BRUNSWICK STEAM ELECTRIC PLANT, UNIT NOS. 1 AND 2
DOCKET NOS. 50-325 AND 50-324/LICENSE NOS. DPR-71 AND DPR-62
RESPONSE TO REQUEST FOR ADDITIONAL INFORMATION REGARDING
REQUEST FOR LICENSE AMENDMENTS - FREQUENCY OF PERFORMANCE-
BASED LEAKAGE RATE TESTING
(NRC TAC NOS. MB3470 AND MB3471)

Response to Request for Additional Information (RAI)

Figure 1

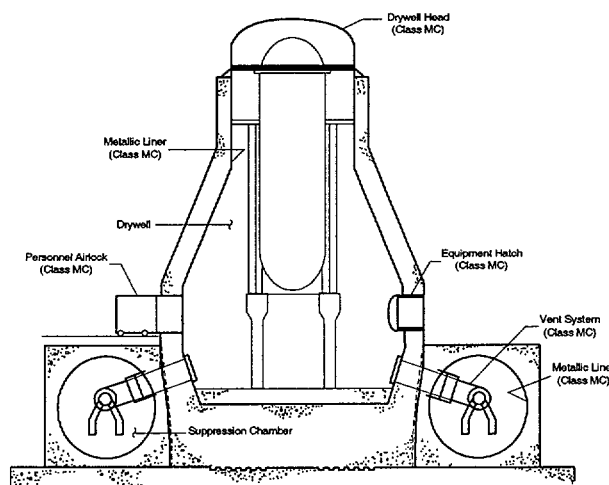
BSEP Units 1 and 2 are BWR-4s with Mark I steel-lined, reinforced concrete primary containments (i.e., refer to Figure 1). The concrete primary containment is comprised of three major components: (1) Drywell, (2) Suppression Chamber, and (3) Vent System.
